SAFETY RECALL NOTICE

CERTAIN SMITH & WESSON MODEL SW1911 PISTOLS BEARING SERIAL NOS. JRD0000 TO JRD4750 CONTAIN A FIRING PIN SAFETY PLUNGER THAT MAY BECOME DISABLED DURING OPERATION COMPROMISING THE PERFORMANCE OF THE FIREARM AND ITS SAFETY SYSTEM. YOU SHOULD STOP USING THE PISTOL AND RETURN IT TO SMITH & WESSON SO THAT AN IMPROVED FIRING PIN SAFETY PLUNGER CAN BE INCORPORATED INTO YOUR HANDGUN.

FIGURE 1

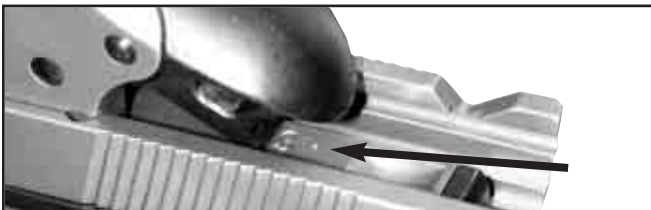
WE HAVE ALREADY BEGUN THE CORRECTIVE ACTION PROCESS ON SW1911 MODELS. TO DETERMINE IF YOUR SW1911 HAS BEEN CORRECTED, PLEASE DO THE FOLLOWING: 1. REMOVE THE MAGAZINE AND BE SURE YOUR FIREARM IS UNLOADED. 2. LOCK THE SLIDE TO THE REAR AND LOOK ON THE BOTTOM OF THE SLIDE FOR A "PUNCH DOT" MARK NEXT TO THE LETTER S (FIG. 1). 3. CHECK THE FIREARM BOX END LABEL FOR A RED "SP" STAMP. (FIG. 2). IF THESE TWO INDICATORS ARE PRESENT, YOUR SW1911 PISTOL HAS ALREADY BEEN MODIFIED AND NO FURTHER ACTION IS REQUIRED.
